CONTRACT MODIFICATION

CONTRACT NUMBER: 25-19

PROJECT DESCRIPTION: Sidewalk Repair Program

CONTRACT MODIFICATION DESCRIPTION: Adding sidewalk ramp replacement
at Wauwatosa Ave. and W. Wright St.

CONCRETE BASE FOR RAPID FLASHING BEACON

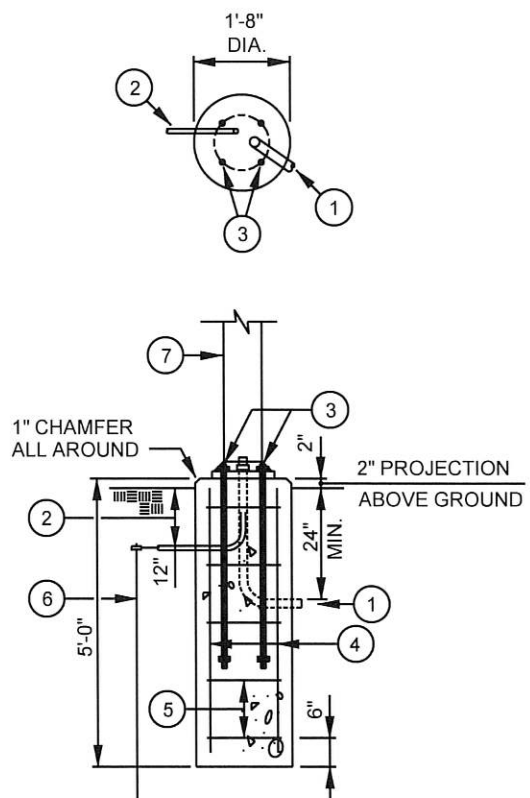
CO2.2 – Item E3-22, Concrete Bases Type 5 – 1 EA @ \$3,450.00/EA = \$3,450.00

Construction Anchor bolts shall be cast into the base as shown on the plans. Anchor bolts to be provided by City. Bolt circle diameters shall be verified before constructing the bases.

Manufactured elbows shall be furnished and installed in all bases by the contractor, except as noted on the details. Elbows shall be installed to permit conduit to be installed in as nearly straight-line runs as possible, without unnecessary bends. Bases not installed to this standard will not be accepted.

Anchor bolts and conduits shall be installed to center the pole on the concrete base to the tolerance as indicated on the plans. Bases not conforming to this requirement are subject to replacement at the sole discretion of the Engineer.
